ADDENDUM NO. 3

DATE OF ISSUANCE:	April 25, 2024
PROJECT:	2024 Addition and Renovations North Harrison Elementary School 1115 W. Whiskey Run Road Ramsey, IN 47166
OWNER:	North Harrison Community Schools
ARCHITECT'S PROJECT NO.:	23-228.001
ORIGINAL BID ISSUE DATE:	April 03, 2024

ISSUED FOR DATE
Public Bidding Addendum #2 04-03-2024
Addendum #3 04-22-2024
04-25-2024

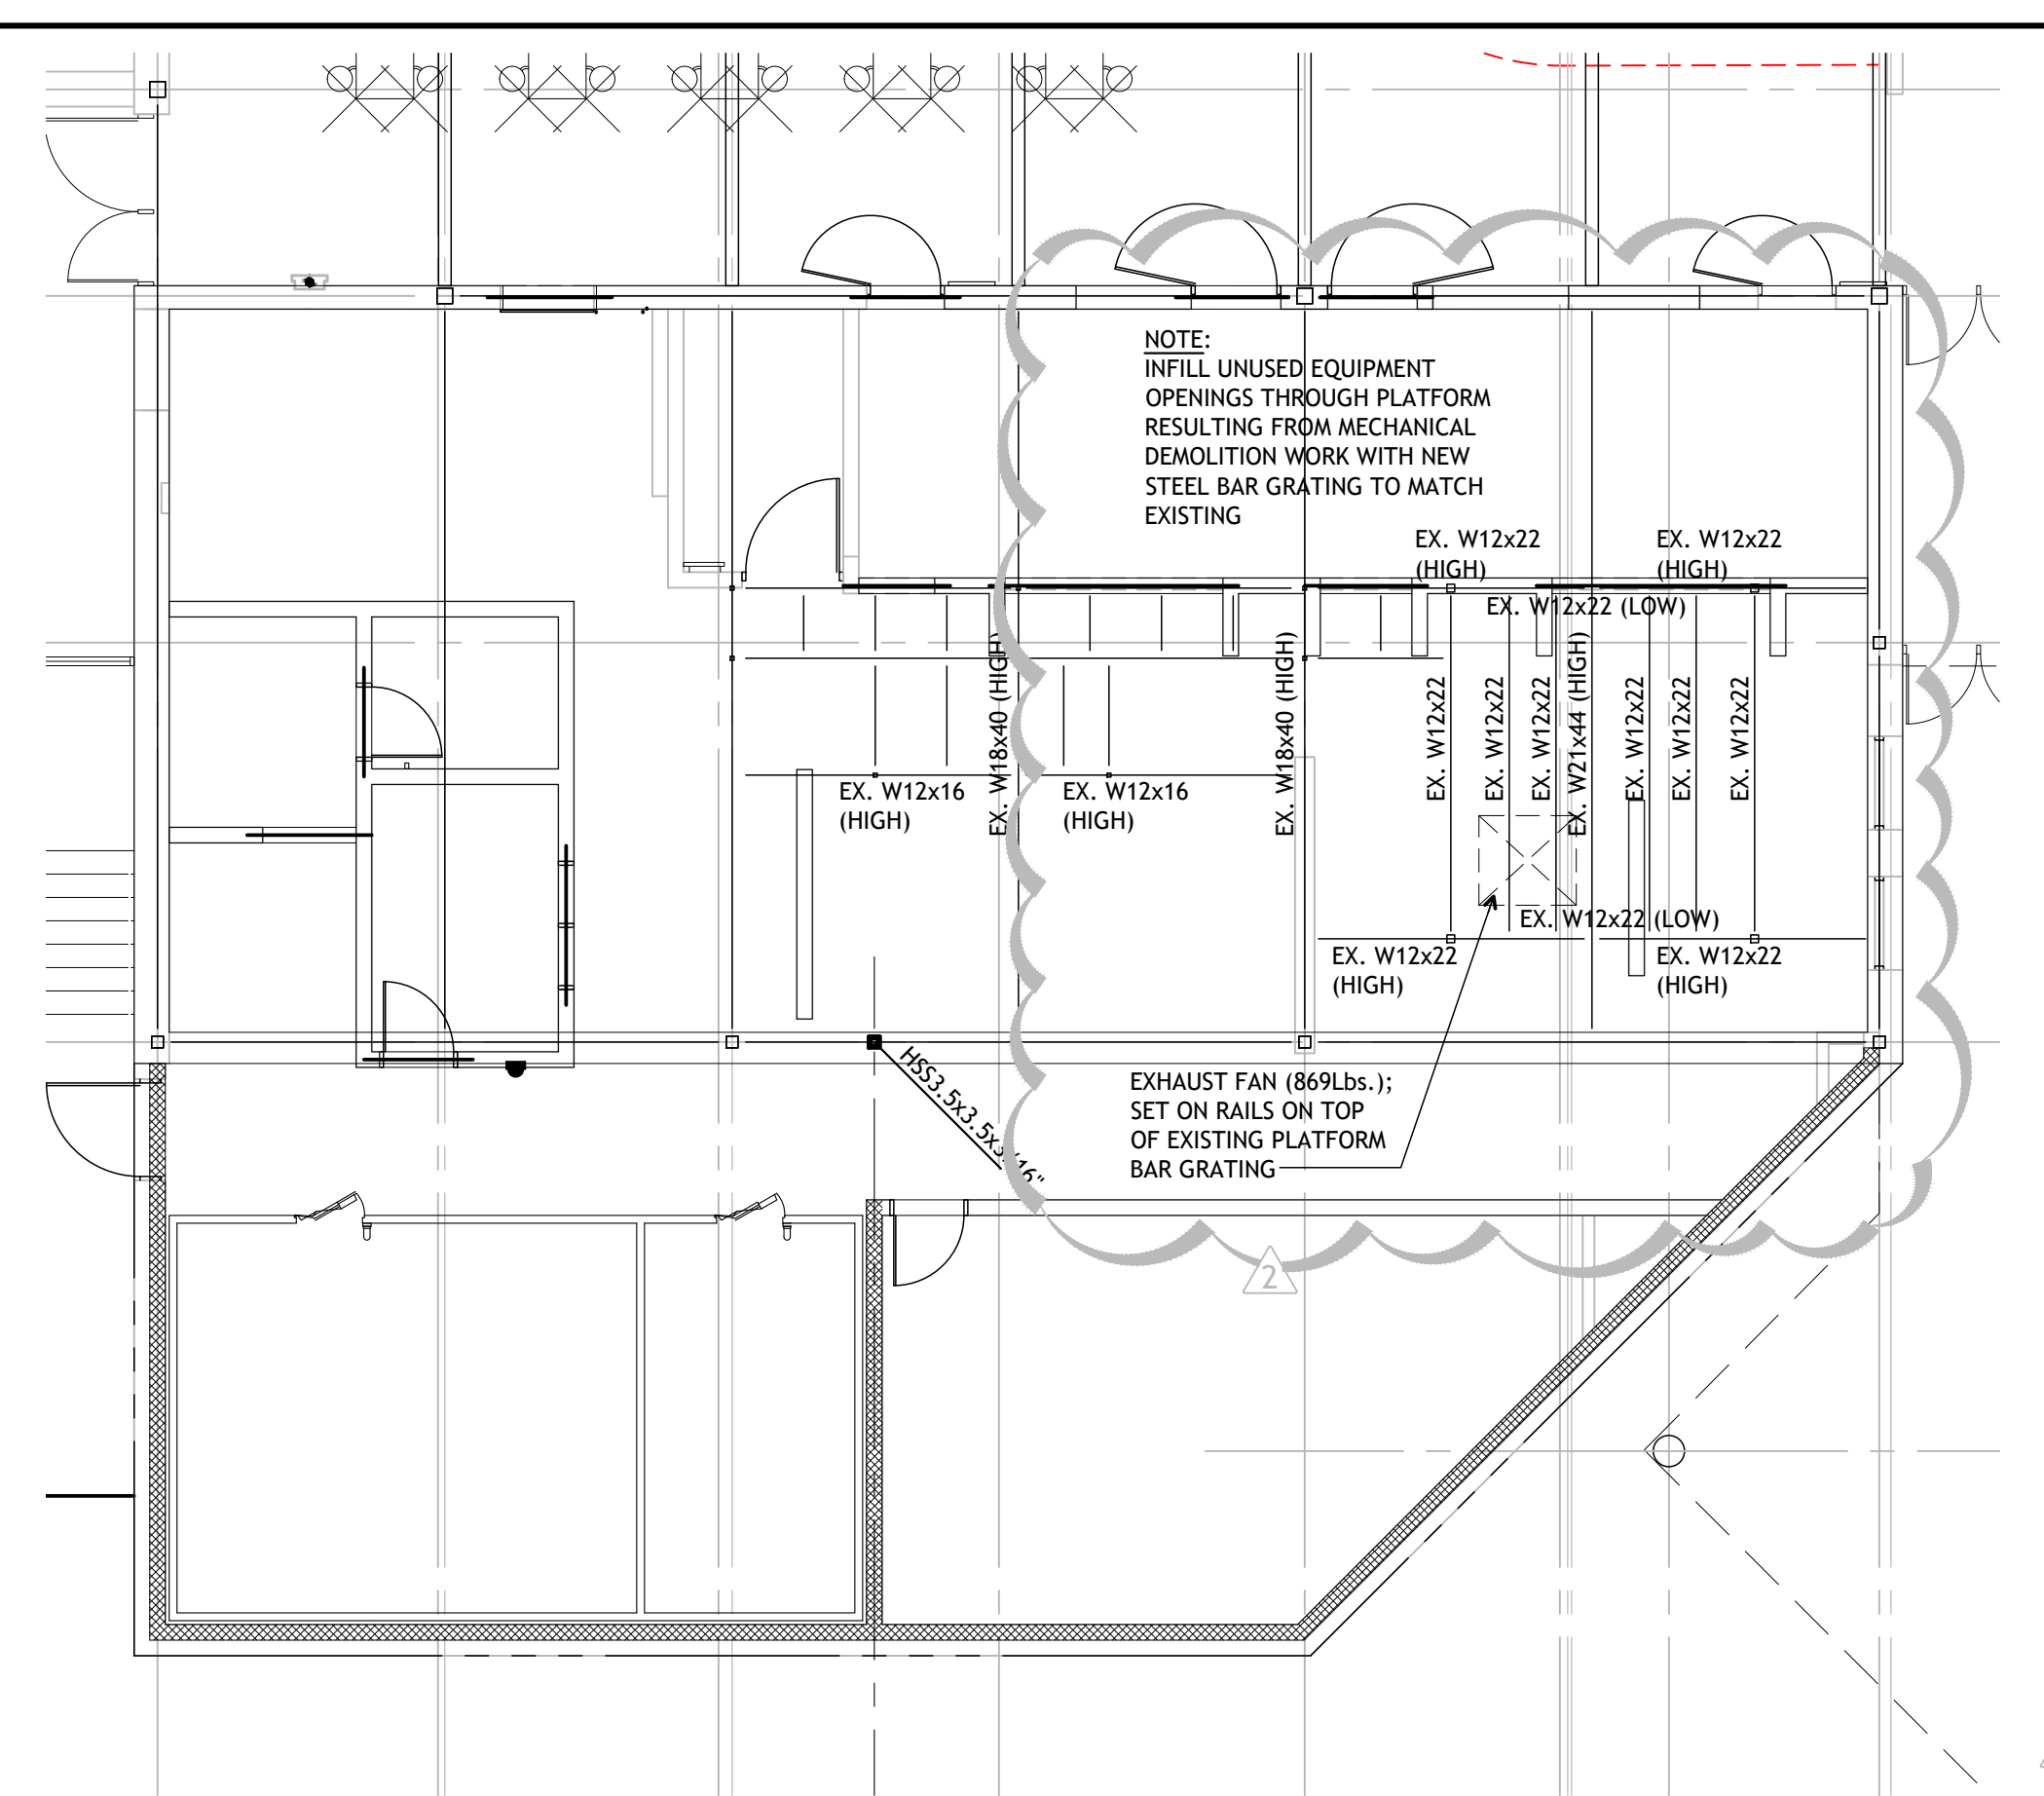
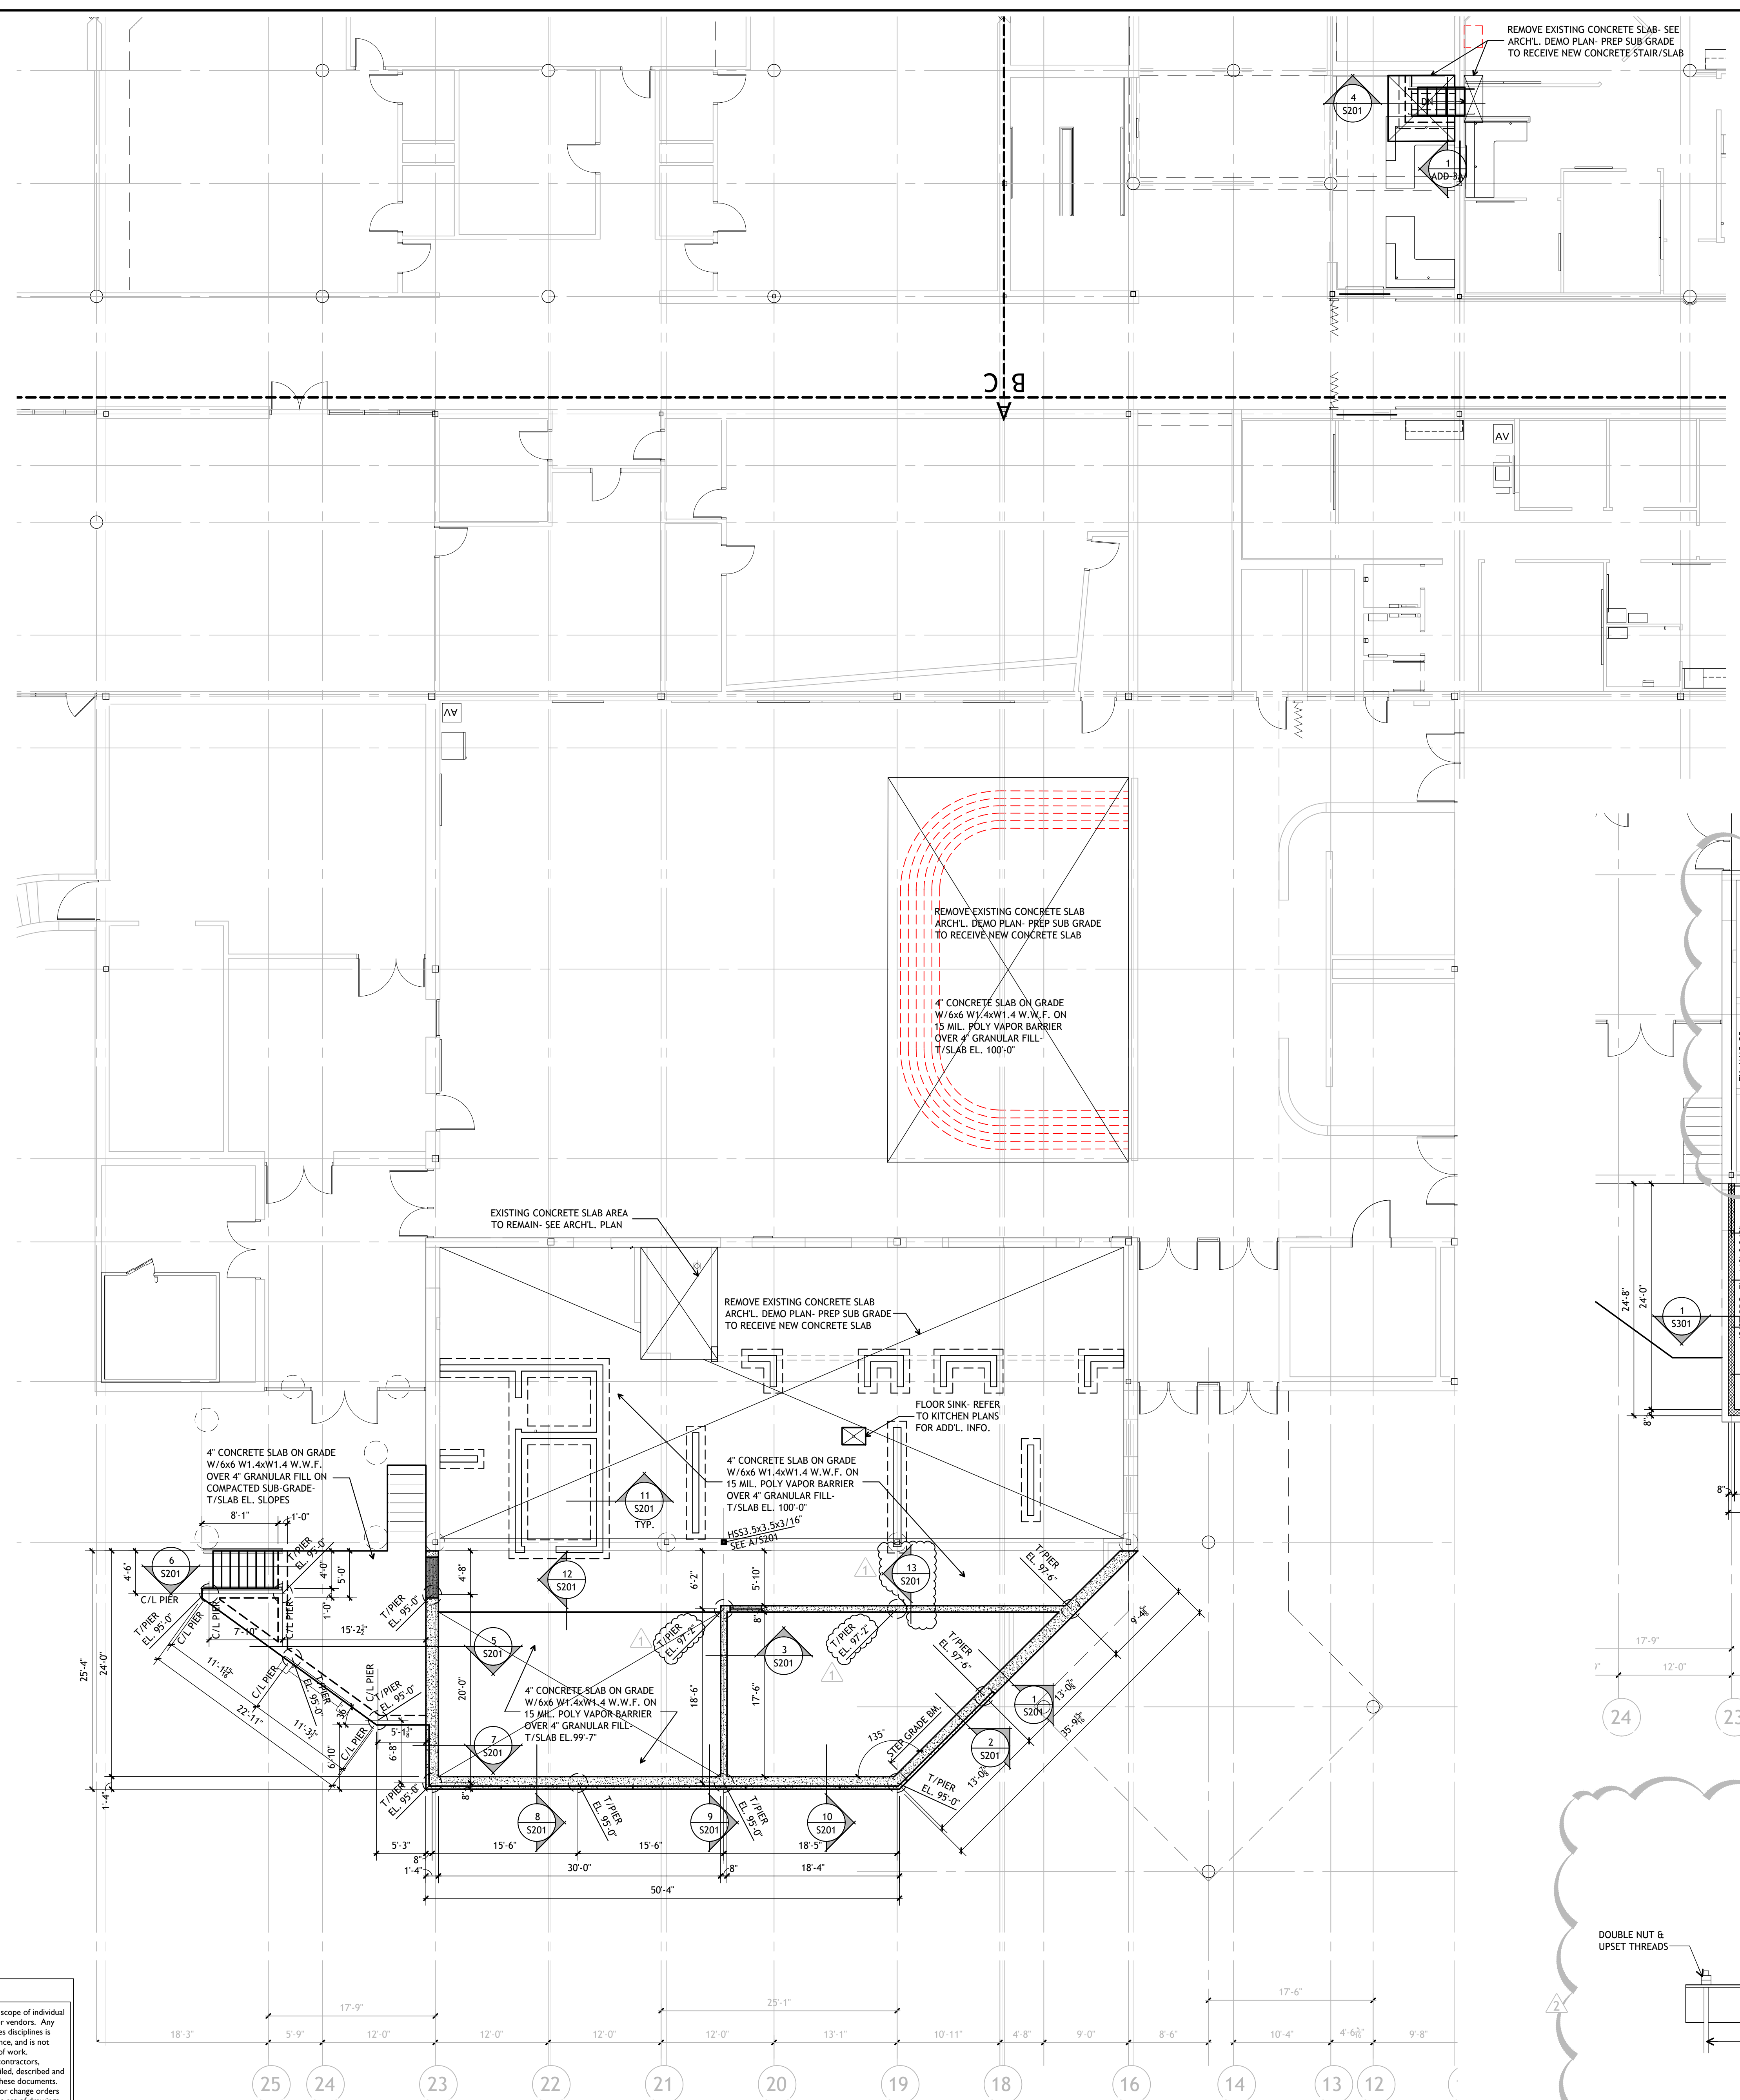
ADD-3 Item No. D-5 - Stair at Reception 103

Refer to Sheet(s): **A703**

Add attached Drawing AD-3C which includes a North-South architectural section through the stair.

SHEET NUMBER
S 101
23-228.001

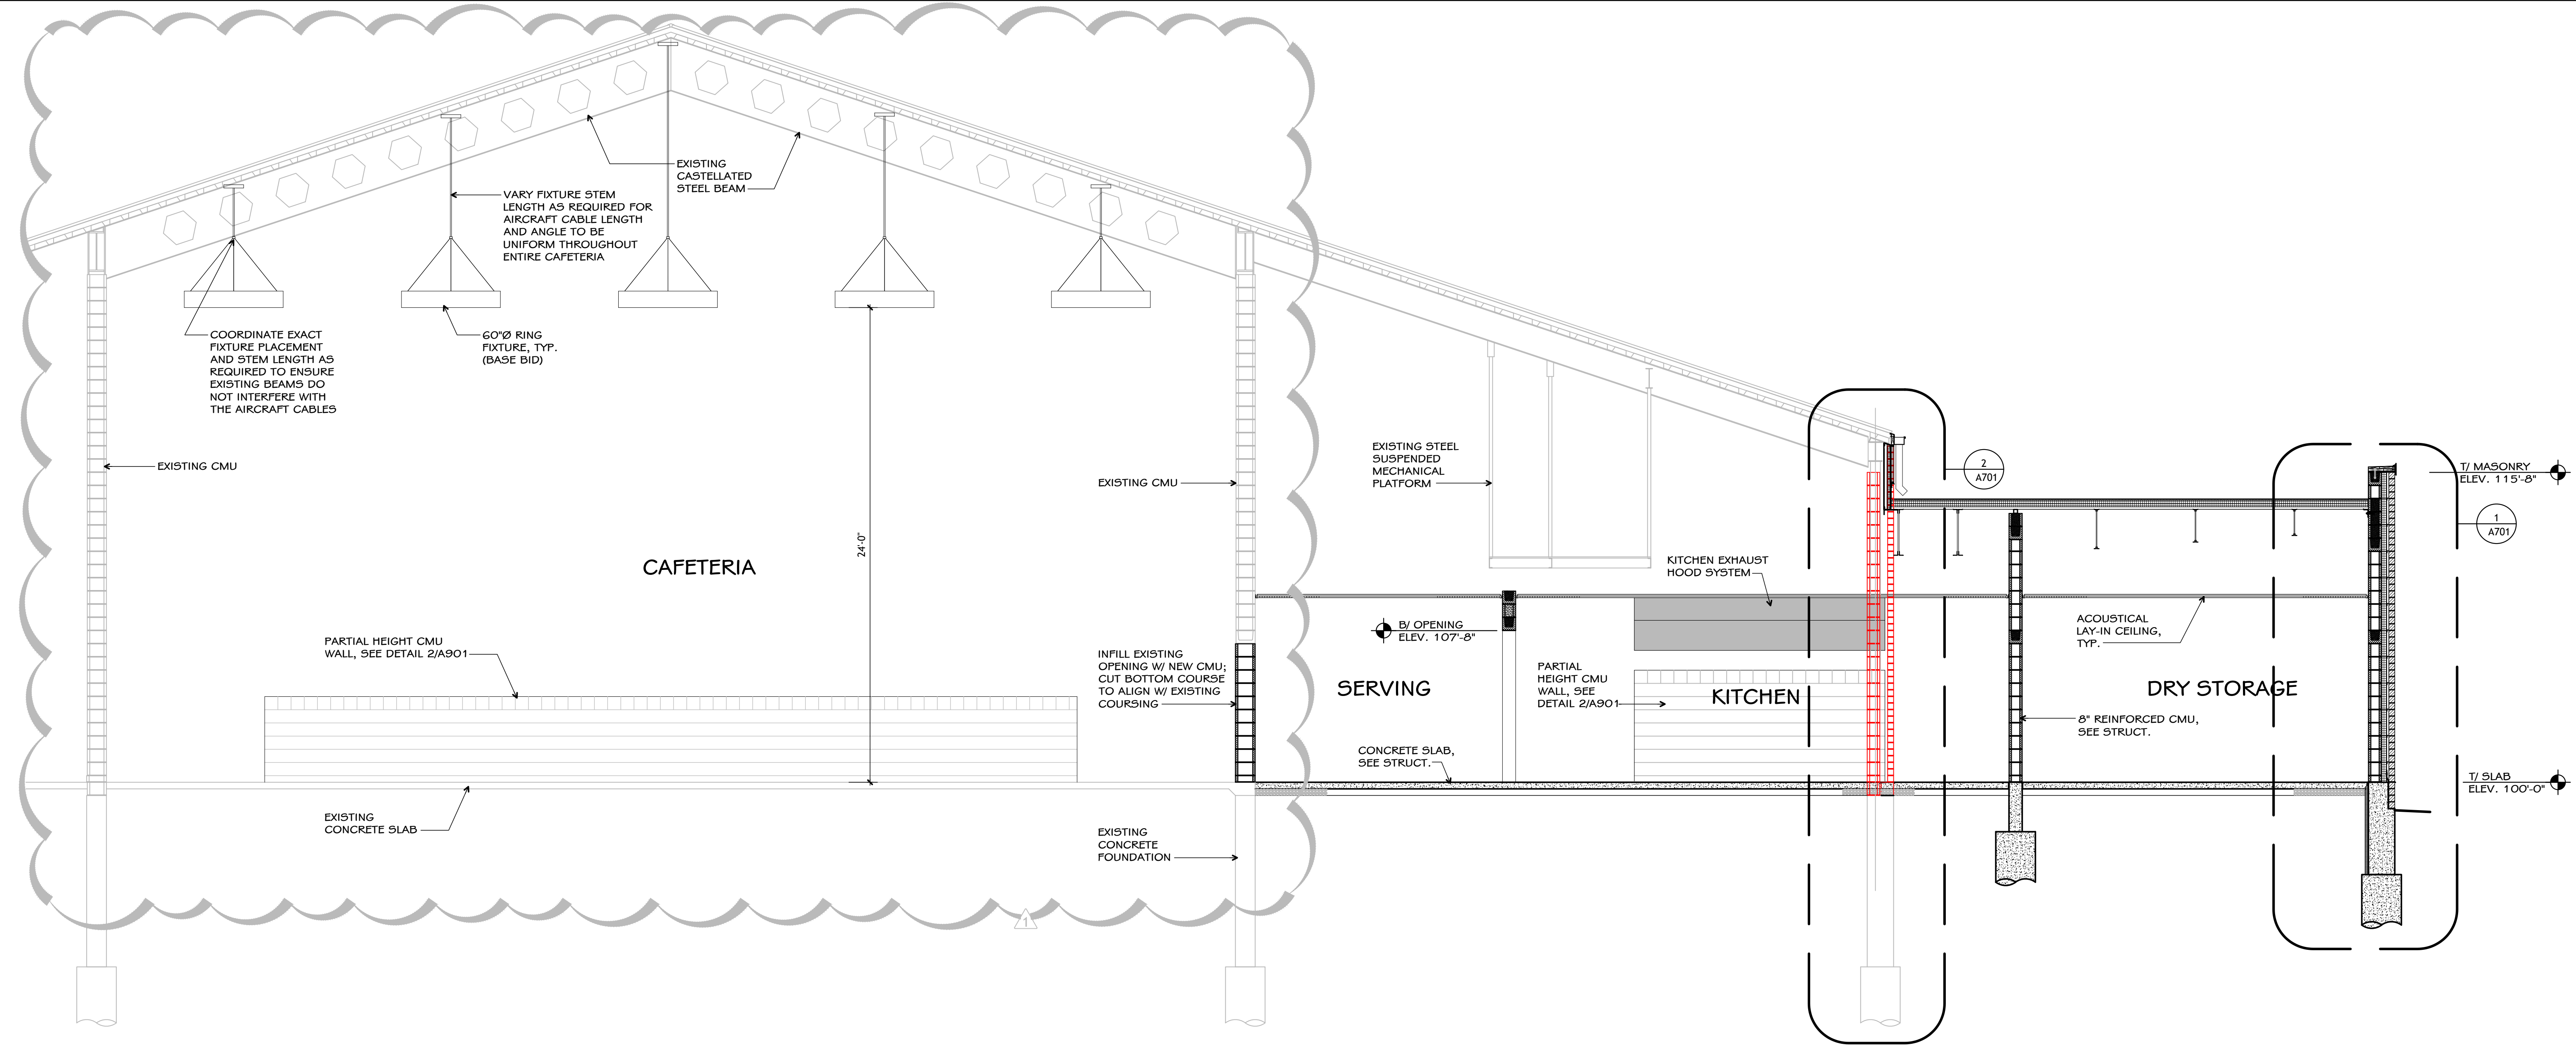
ADD-3 Item No. D-3 - Kitchen Equipment Supports

Refer to Sheet(s): **S101**

Replace with attached revised Drawing in its entirety; revisions have been clouded for reference. Steel framing added to support new kitchen exhaust hoods.
